CITY OF ALBUQUERQUE

**Re; Lot 9, Blk 13 Volcano Cliffs SAD 227
6519 Jade NW
Grading and Drainage Plan for Pool
Engineers Stamp Date: 6/26/2021 E10D062**

TITLE:
ENLARGED GRADING PLAN

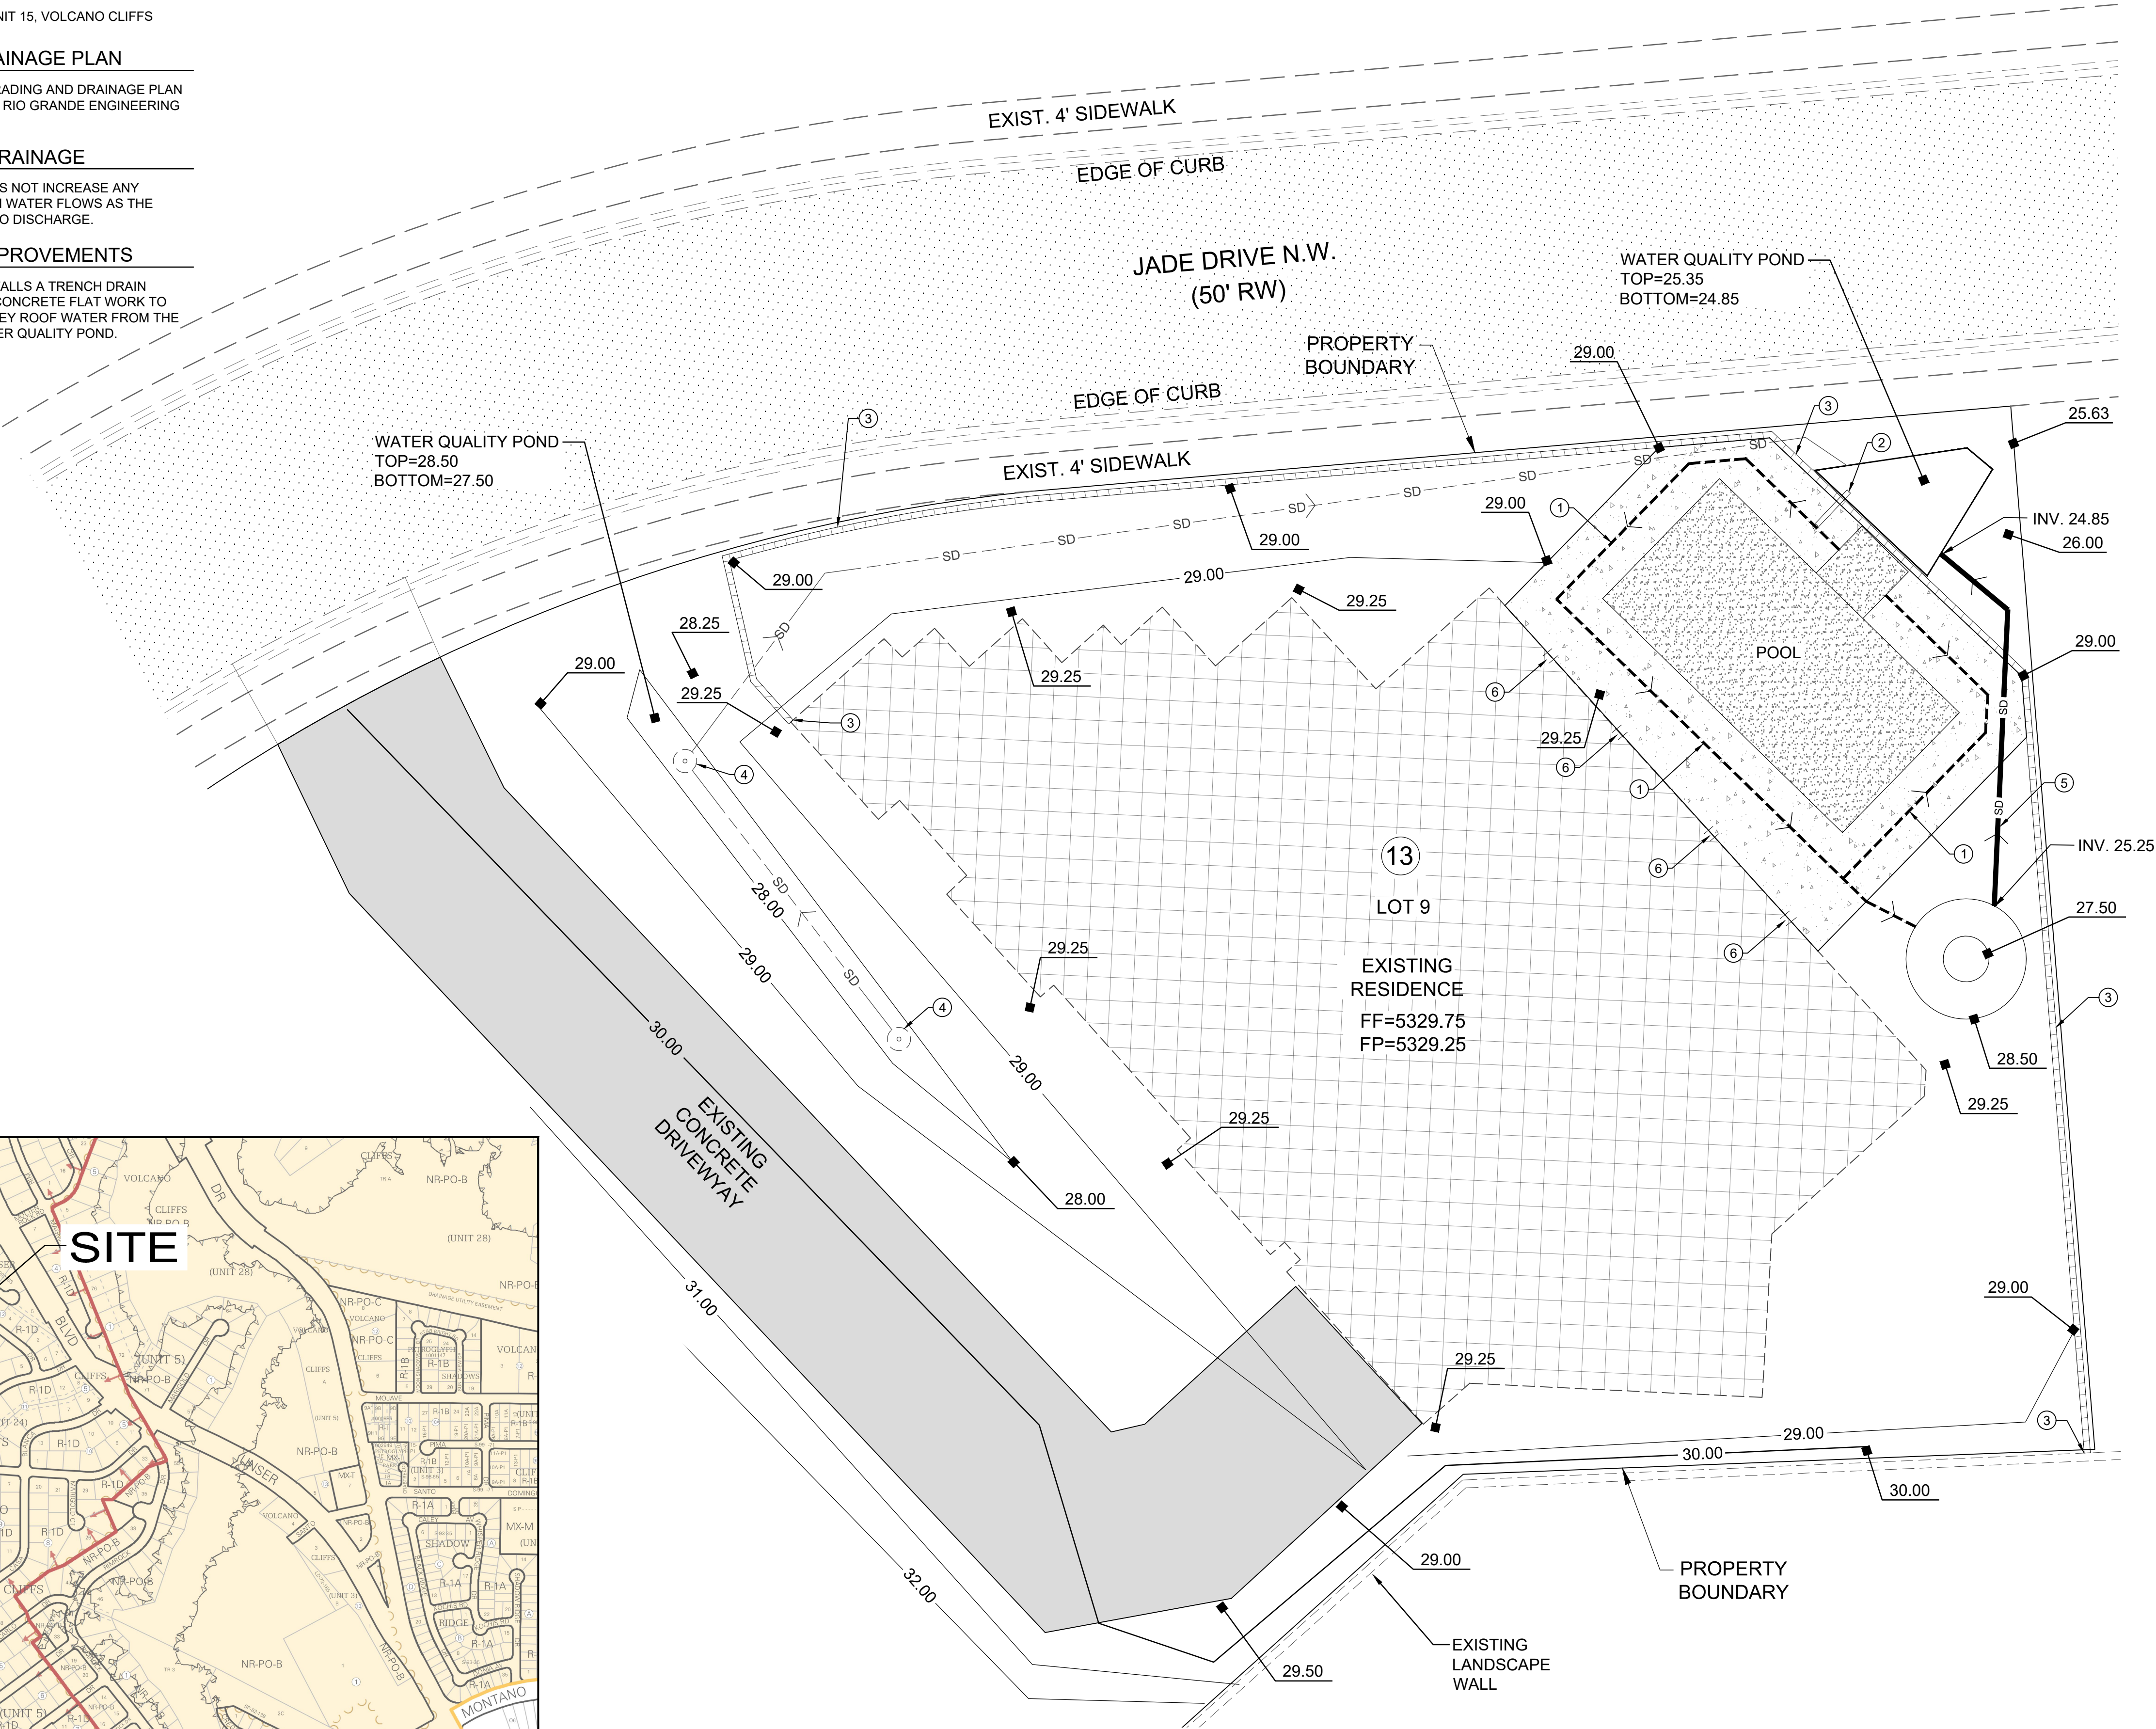
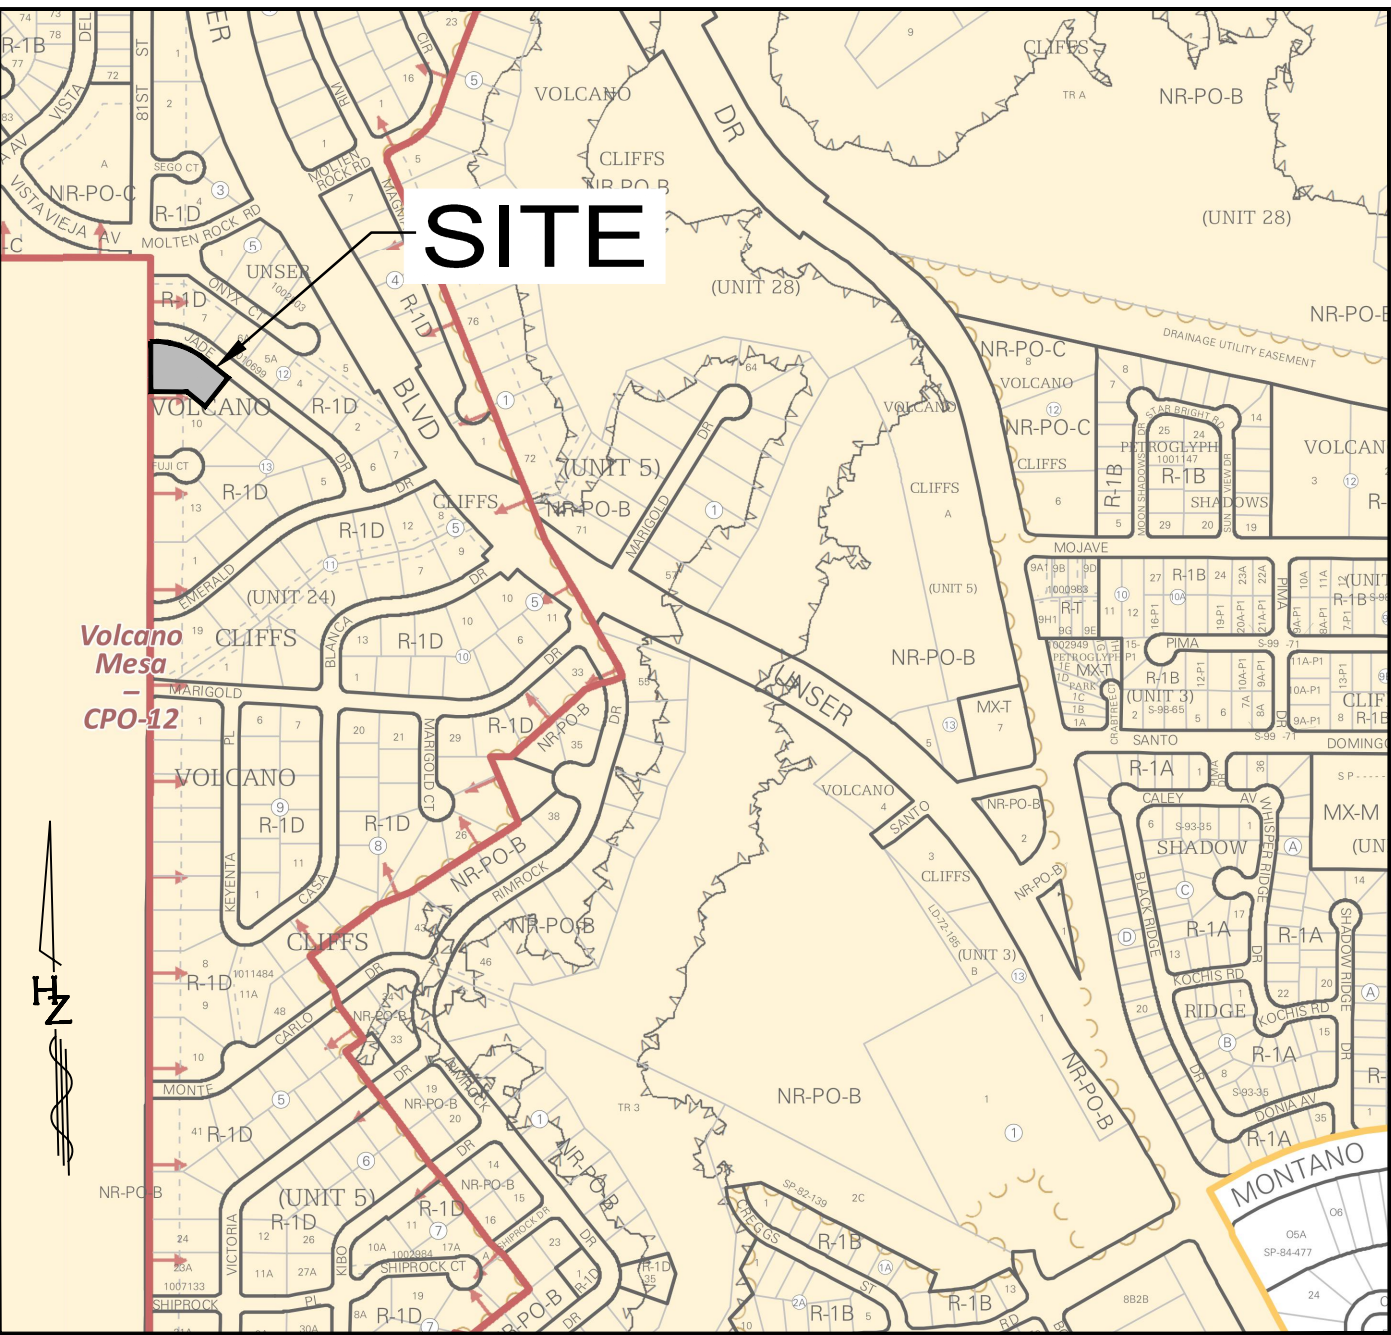
- The pool needs to be placed on the approved G&D plan. If you wish for the pool to be separate from the original G&D a CO must be approved on the original permit.
- Provide a table of the land treatments.
- Provide if the ponding areas should keep the same capacity or a greater capacity. The pool is located where the original ponding area was required.
- Provide the outlet spot elevation for the pond when overflowing.
- Provide erosion control for the pond.
